**DERBYSHIRE COUNTY COUNCIL**

**11 January 2018**

Report of the Strategic Director – Economy, Transport and Environment

**RESULTS OF CONSULTATION FOR A NEW SHARED USE CYCLE PATH,  
B6057 BETWEEN DRONFIELD AND UNSTONE**

Unstone to Dronfield Cycle Link - Consultation Drawing

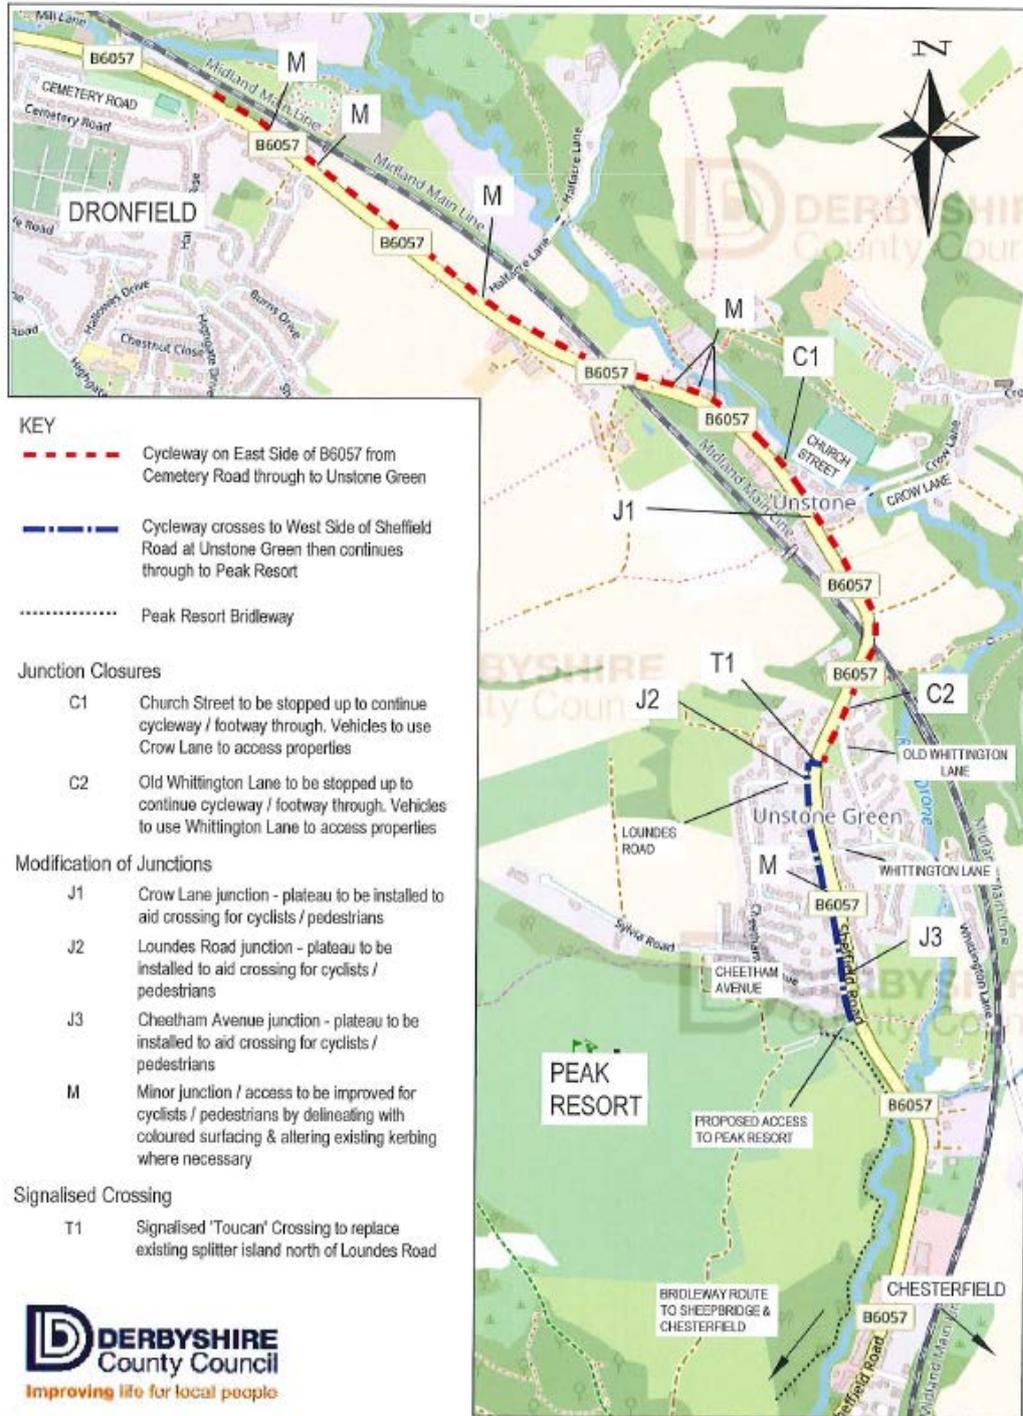
Consultations have been carried out, including a letter drop to households overlooking and adjacent to the proposed route, and also with local stakeholders including Dronfield Town Council and Unstone Parish Council. The route proposals were also discussed at a meeting with representatives from Chesterfield and Dronfield cycling groups and North East Derbyshire District Council. Officers have also attended Unstone Parish Council meetings and agreed draft proposals for connections into Peak Resort with the site developers. During the consultation period, 31 responses were received. Fourteen of these make statements in support of the proposal and a further five have no objections but make queries or highlight concerns. Twelve responses make objections to the proposal. Some responses were made from joint email accounts or contained additional signatories; in total, the consultation generated over 100 separate comments or queries about the proposals. Officers have responded to everyone that made comments and have met individual residents where requests for further public discussion have been received. Appendix 2 summaries the Officer responses made.

A summary of the main objections and concerns about the proposal are as follows:

- Localised road narrowing will have a negative impact on congestion, pollution and road safety.
- A route alongside the B6057 would be too dangerous for families due to a high volume of traffic and significant gradients.

- Risk of collisions between pedestrians and cyclists on the shared path, particularly in regard to cycle speeds.
- Concern about the impact of the proposals on the Post Office during the construction phase and as a consequence of road narrowing.

- Concern about conflict outside Unstone Junior School.
- Other route options should be considered.
- More detail required about how the route would be provided under the railway bridge on Unstone Hill, and concern about cycle speed.

- Loss of the bus layby on Chesterfield Road, Dronfield.
- The money would be better spent elsewhere, e.g. supporting local bus services, improving crossings, etc.

- Requests for visibility improvements at Cheetham Avenue junction.
- Requests to retain the pedestrian refuge at Cheetham Avenue.
- Request for more detail of proposals at Crow Lane junction and impact on volume of traffic.
- Queries about facilities for turning traffic associated with closure of Church Street junction.
- Queries about onward cycle connections to leisure attractions.
- Queries about impact on trees and vegetation.

- Request for more detail for proposals at the footbridge across the railway line.

The proposal seeks to widen existing footways by utilising road verges, where possible, for the creation of a cycle path. However, in several locations the lack of adequate highway verge requires the road to be narrowed to a minimum width of 6.5 metres to achieve a satisfactory shared footway width.

Officers have considered whether a reduction in road width would negatively impact on the operation of the B6057 and on pollution and road safety. Traffic surveys were carried out over a weekly period at three locations in Unstone village and show that the route supports average daily traffic flows between 10,000 and 11,000 vehicles and reflects its status as a local connection between Dronfield and Unstone communities and the A61 and Chesterfield.

It is therefore considered that the opportunity to provide physical measures to narrow the road where there is good forward visibility will introduce a more positive, physical effect to help reduce vehicle speeds and will help improve safety for all road users.

and before any measures are implemented. Several respondents referred to concern about high cycle speeds. It is recommended that additional signage (“Slow”) and cycle markings are provided where appropriate to advise cyclists to slow down and to take extra caution.
